ADDENDUM NO.: 3

DATE OF ADDENDUM: May 18, 2016

**Renovations to Litchfield Residence Hall
Western Connecticut State University
183 White Street
Danbury, CT
CF – RD – 275**

1 ENLARGED FIRST FLOOR PLAN (PARTIAL)
1/4"=1'-0"

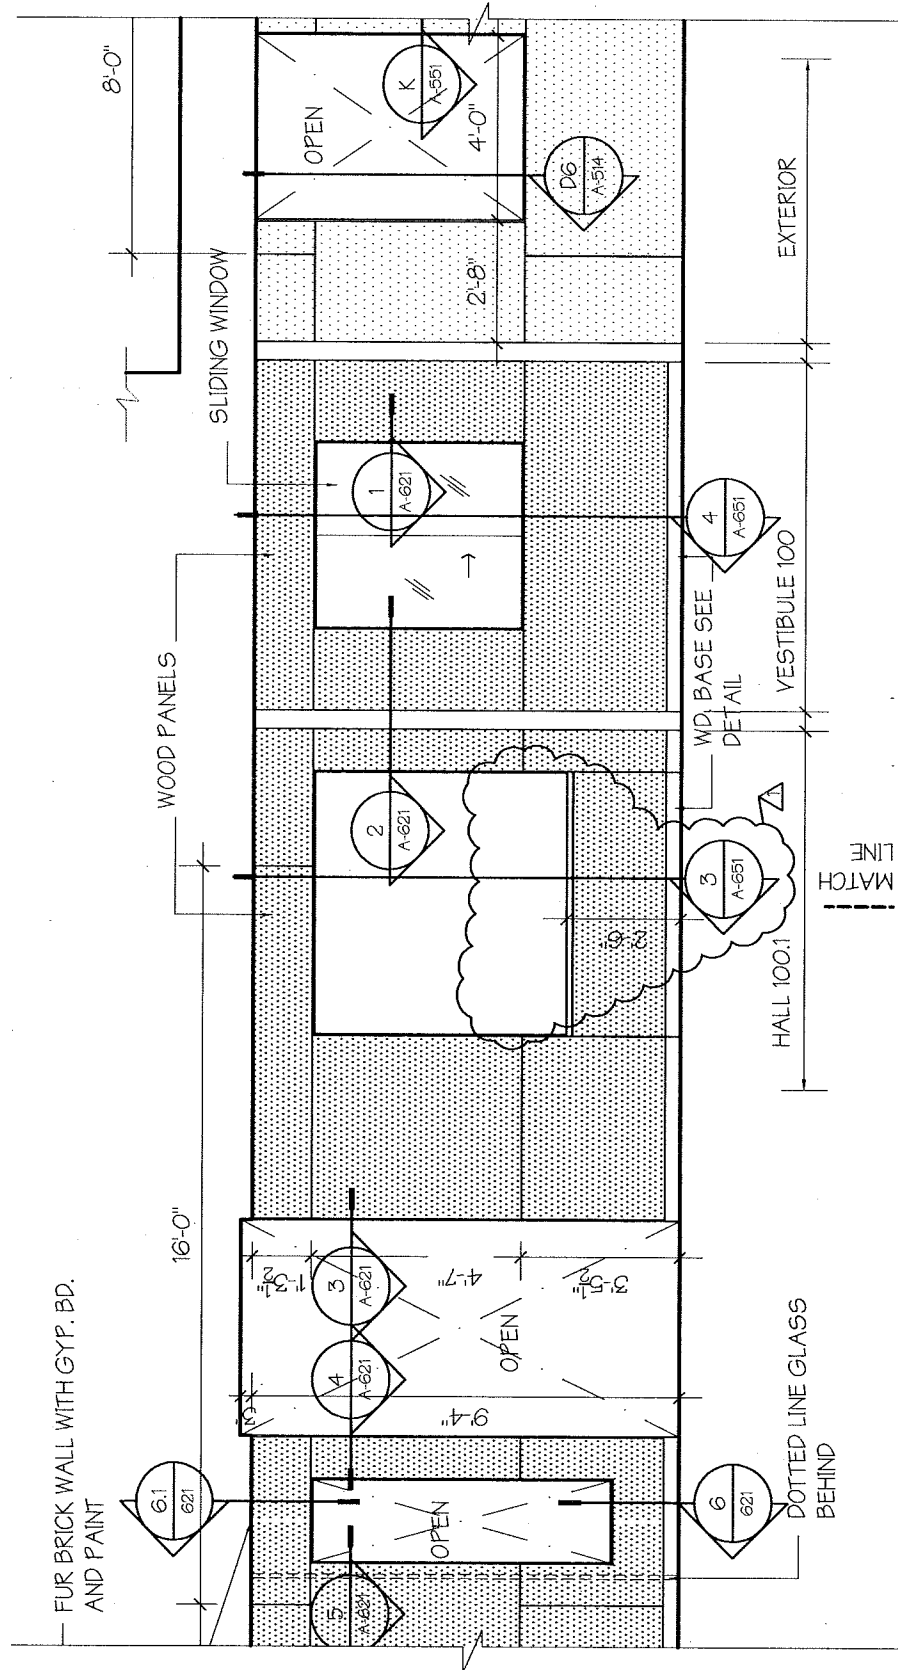
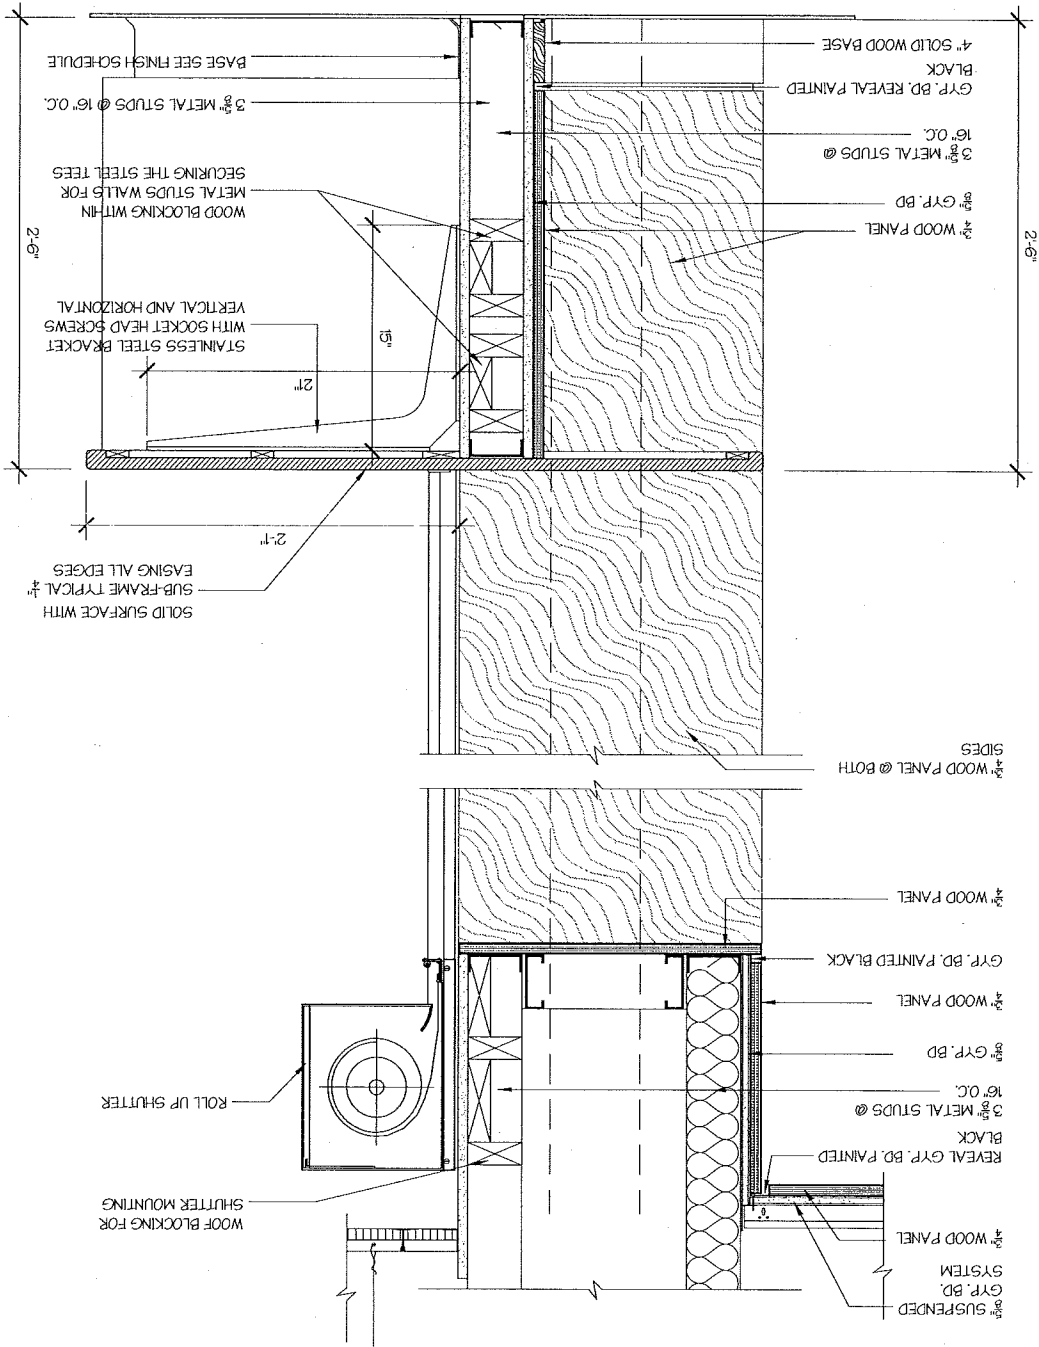
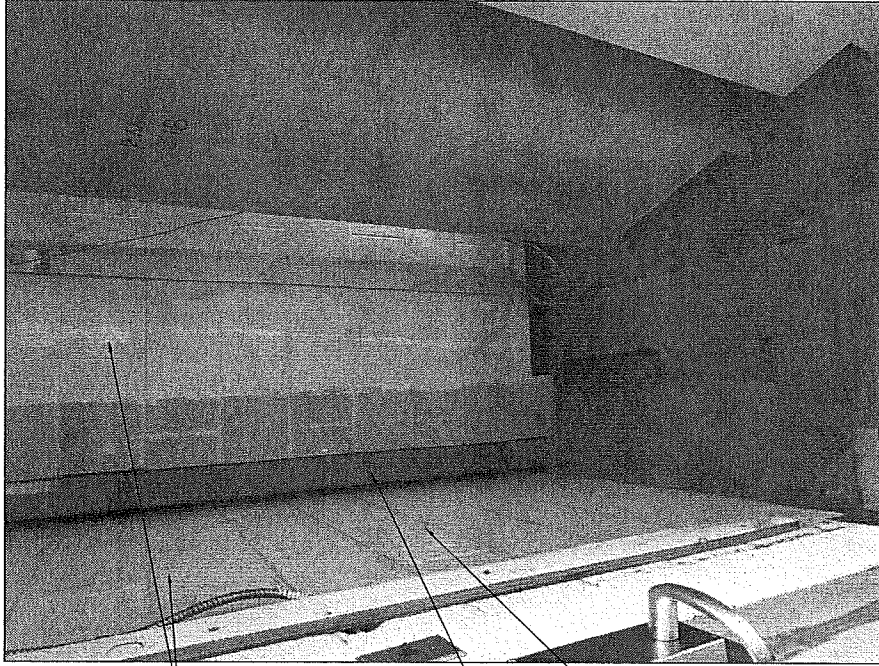
Drawing A-301, A-60, A-651

Revise counter per SKA-01, SKA-02 & SKA-03 Attached.

1 INTERIOR ELEVATION HALL 100.1 (PARTIAL)
A-601 1/4"=1'-0"

NOTE:
COORDINATE INTERIOR ELEVATION CHANGES
WITH 4/A-602 (OTHER SIDE OF WALL AT COUNTER)

3 COUNTER @ OFFICE 139
A-651 1-1/2"=1'-0"

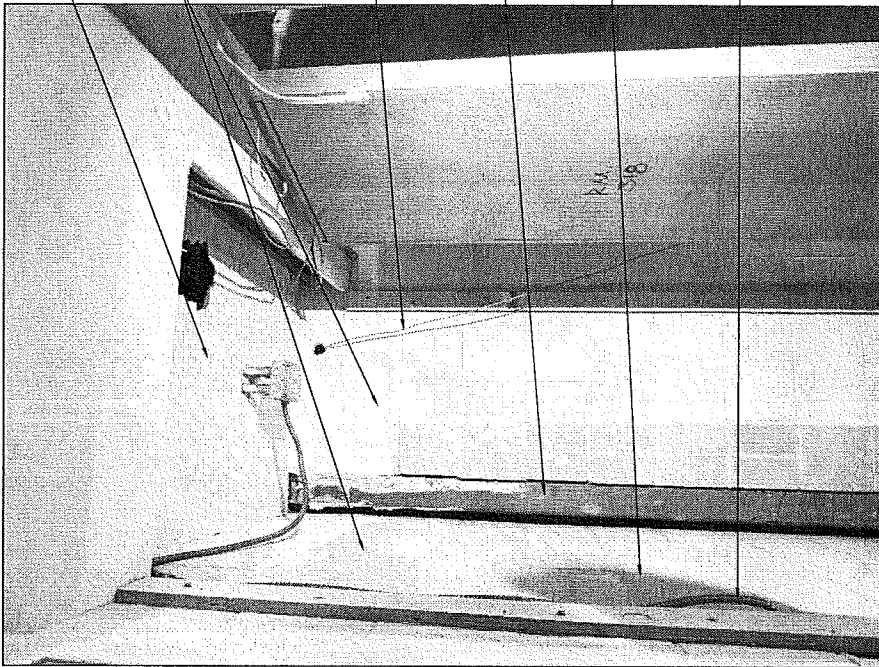
Drawing A-602 Detail 11, 12, 13 & 14, General Note for existing millwork and ED-101, 102 & 103 note 14.

DELETE: Drawing A-602 Detail 11, 12, 13 & 14, General Note for existing millwork and ED-101, 102 & 103 note 14.

ADD: SKA-4 (attached) detailing repair work at removed wardrobe millwork locations.

STUD OPENING IN SOFFIT ABOVE AND PROVIDE 3/8" GYP BOARD TO BE FLUSH WITH EXISTING SOFFIT.

FUR OUT BOTH WALLS WHERE WARDROBE IS REMOVED WITH 3/8" METAL FURRING CHANNEL AND 3/8" GYP WALL BOARD TO CONCEAL EXISTING POWER AND DATA WIRING. PROVIDE NO-COAT STRUCTURAL LAMINATE DRYWALL CORNER SYSTEM OR EQUAL.

SECURE DATA CABLES TO WALL EVERY 24 IN WITH NYLON CABLE CLAMP TIES (PANDUIT PART NO. P1C191-55-C OR APPROVED EQUIVALENT). PRESERVE CABLE BEND RADIUS PER TIA-568-C STANDARDS.

FUR OUT AROUND COLUMNS THAT PROTRUDED INTO ROOMS. SEE FLOOR PLANS FOR LOCATIONS.
